IN THE DRAWINGS:

REMARKS

Fig. 7

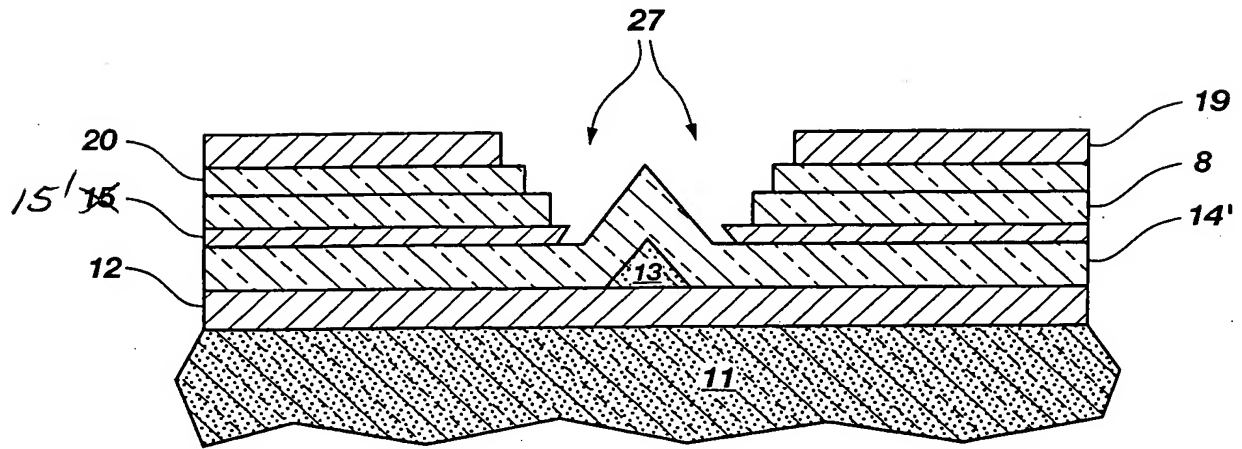
Specifically, FIG. 7 has been revised to change the reference numeral "15" to --15'-- to eliminate redundancy with previously used reference numerals; FIG. 8 has been revised to delete the reference numeral "14" and to insert a new reference numeral --14'-- with appropriate lead line; and FIG. 14 has been revised to change reference numeral "14" to --14'-- to eliminate redundancy with previously used reference numerals. No new matter has been added.
